## **Errata** 11/14/2013 for

## **Old-Time Telephones!**

Ralph O. Meyer

## **Errata**

Fig. 17-14 Corrected

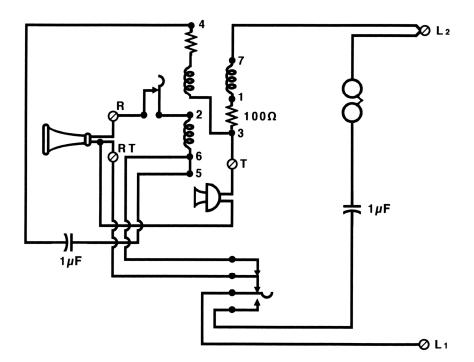
- Page 121. In the section heading, replace the last word "Dial" with "Dials."
- Page 137. In Fig. 17-14, interchange the labels L1 and L2 (modified figure provided below).

Fig. 18-7 Corrected

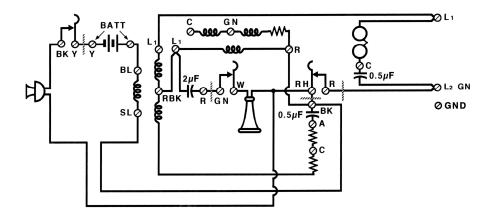
- Page 140. In Fig. 17-18, interchange the labels 8 and 6 (modified figure provided below).
- Page 151. In Fig. 18-7, add two terminal labels, L1 and GND (modified figure provided below).

Fig. 18-9 Corrected

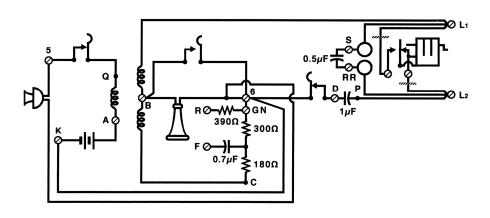
- Page 153. Seven lines down, replace "rear of the phone" with "front of the phone."
- Page 154. In Fig. 18-9 at terminal Q, replace the symbol for a screw terminal with the symbol for a solder terminal (modified figure provided below).
